CONTRACT CHANGE ORDER NO. _____
SHEET ____ OF ____

MARK	DATE	DESCRIPTIONS	BY	CH'D	CCO#
1	09/16/11	TOWER SUSPENDER CABLE & ELEVATOR	NV	MN	203S1
0	05/11/11	PARAPET WALL AT TOWER HEAD	NV	MN	196

SAN FRANCISCO OAKLAND BAY BRIDGE
EAST SPAN SEISMIC SAFETY PROJECT
SELF-ANCHORED SUSPENSION BRIDGE
(SUPERSTRUCTURE & TOWER)

PARAPET WALL AT TOWER HEAD DETAILS NO. 2

DETAIL A
1:10

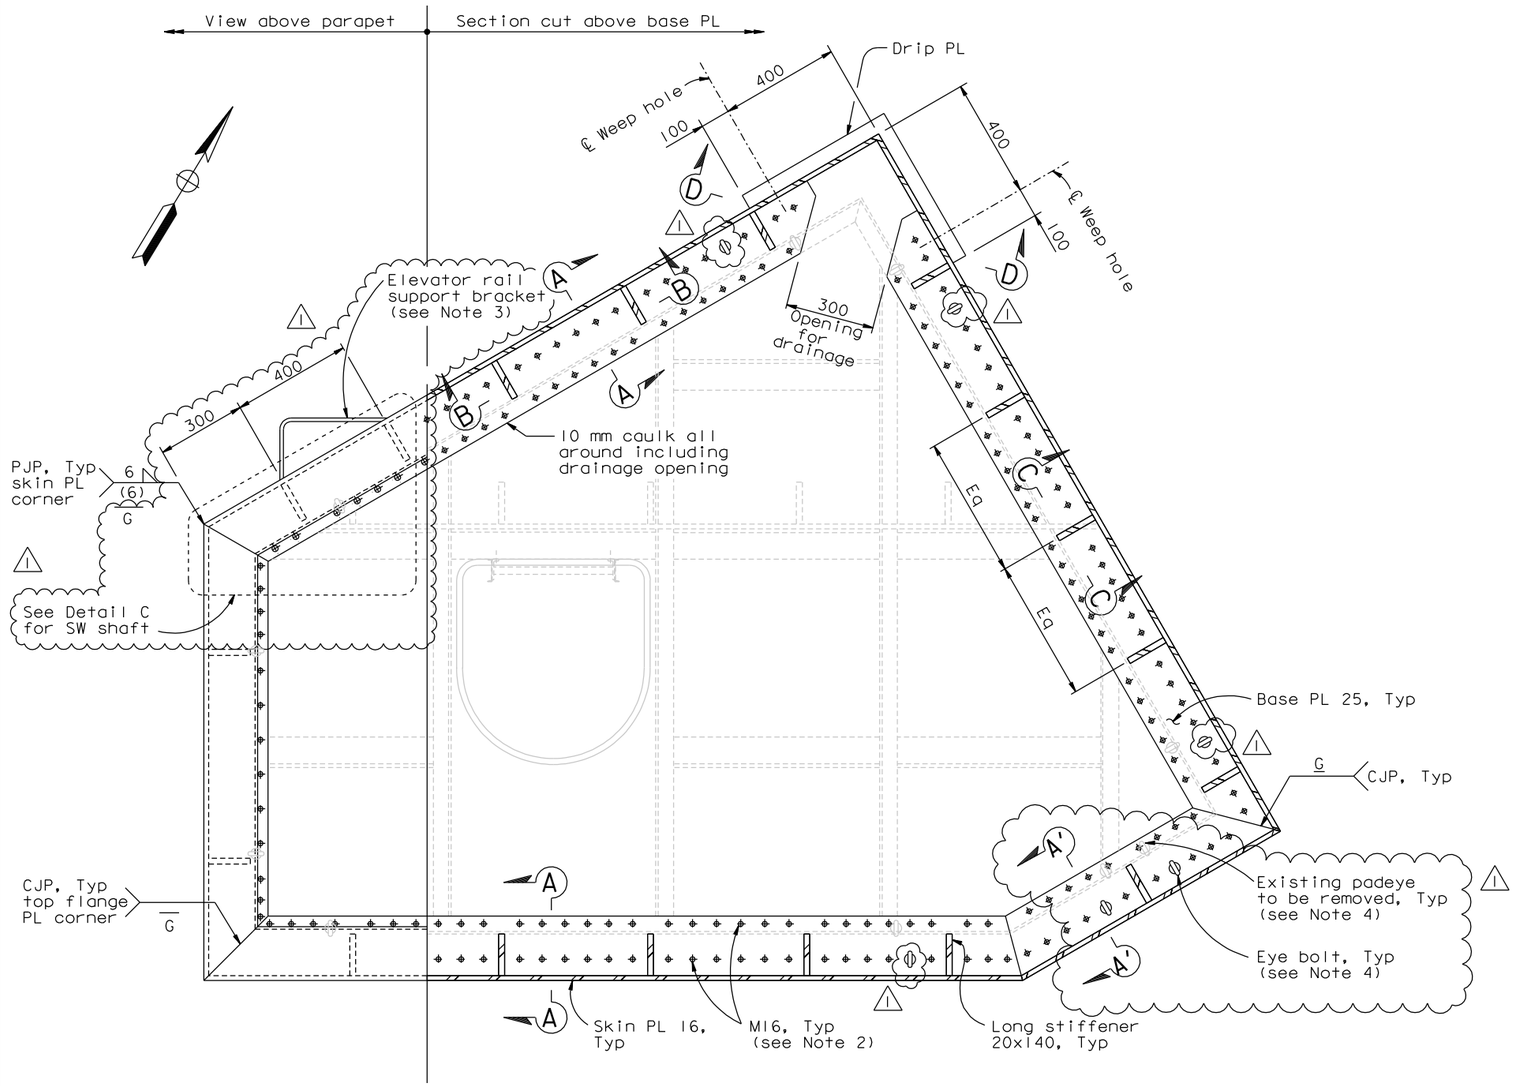
1. For Sections A-A, A'-A', B-B, C-C and D-D, see "Parapet Wall At Tower Head Details No. 3" sheet.
2. At the Contractor's option, 5/8 inch Dia A325 HS bolts may be used in lieu of M16 A325M bolts.
3. For details of elevator rail support bracket, see "Tower Elevator Extension Details" sheets.
4. Replace each existing padeye to be removed as follows:

Bolted option:

Install 16 mm Dia x 100 mm long Crosby forged shoulder eye bolt or equivalent at location shown in the base plate (must be between 2 HS bolts and not adjacent to stiffener). Spacer plate shall be provided to ensure full thread engagement of the nut. Nut shall be installed snug-tight. Jam nut or lock nut shall be used to prevent bolt nut from backing off. See Section A'-A'.

Welded option:

Install Crosby No. 4 padeye or equivalent as close to skin plate and adjacent stiffener as possible with the required clearance for all-around welding of padeye to base plate.

DETAIL C (SW shaft)
1:10

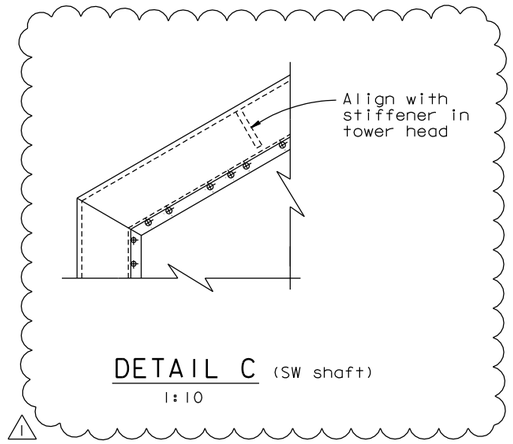
(NE shaft shown; SW shaft similar except as noted in Detail C)
